TEXAS UTILITIES GENERATING
COMPANY, et al.

(Comanche Peak Steam Electric Station
Station, Units 1 and 2)

CASE'S ANSWER TO APPLICANTS' REPLY TO CASE'S ANSWER TO
APPLICANTS' MOTION FOR SUMMARY DISPOSITION
REGARDING CONSIDERATION OF FRICTION LOADS

AFFIDAVIT OF CASE WITNESS MARK WALSH

FIGURE 1

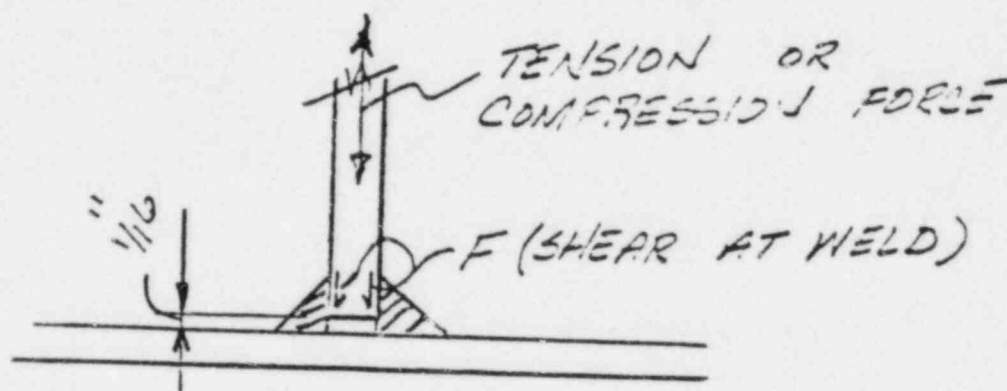
The capacity of the weld actually must be based on a shear stress between the weld and the base metal. This is a requirement of the AISC code, 7th Edition, Supplement No. 3, as indicated in Table 1.5.3. (to which Applicants are committed), as indicated under "Fillet Welds." (See Attachment A hereto.) The load is transferred through shear from the base metal to the weld, and therefore, all the normal forces, designated as Fn on line 12 of the calculation, must be additive. This additive effect need not be in the code (although it is), but based on engineering judgement, it

would have to be additive. As shown in Figure 1 below, there is a gap between the base metal and the attaching member. This gap is normally found in the field and is acceptable up to 1/16"; i.e., there will be no nonconforming conditions if a 1/16" fit-up gap is inspected prior to welding. Since the force from the attaching member must pass the load by shear through the weld (designated by F in the diagram below), it is easily seen that whether the load is axial compression or tension is of no importance in this regard.
